**STAFF REPORT:** 10/09/2024 REGULAR MEETING

**APPLICATION NUMBER:** HDC2024-00520

**ADDRESS:** 15107 MINOCK

**SCOPE:** DEMOLISH GARAGE, ERECT GARAGE; REPLACE DOORS AND WINDOWS (WORK COMPLETED WITHOUT APPROVAL)

Figure 6, by Applicant: proposed site plan showing garage, driveway and service walk locations.

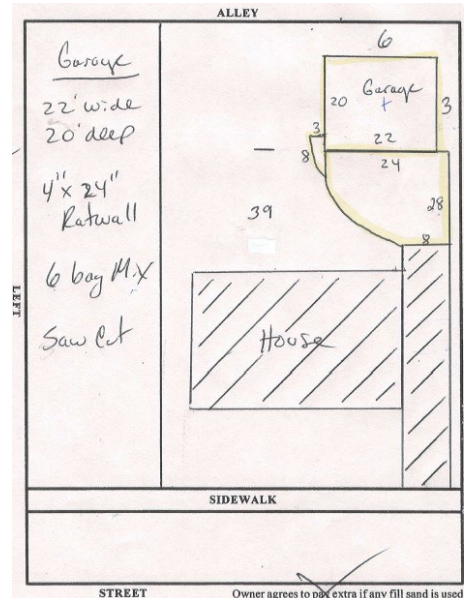
- Staff has no issue with the proposed concrete driveway and walkway should the Commission decide that the construction of new garage is appropriate. (See Fig 6.)

Figure 7, by Applicant: showing proposed front elevation of the garage.

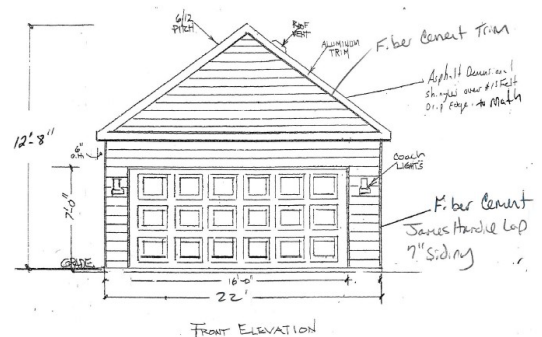
- As described above, staff does not recommend replacement of the existing garage. We will however, for the Commissioners' information, assess the appropriateness of the new garage, independent of this consideration. Staff has the opinion that the proposed height, scale and design of the new garage is appropriate that is deferential to the

primary structure, i.e., the house and meets the Elements of Design, i.e., “relates to the main dwelling”. Staff opines that a smooth finish cementitious board of a narrower reveal dimension and a color scheme that follows the HDC color guidelines for Color System C would be appropriate alternatives should the Commission decide that the construction of a new garage is appropriate.
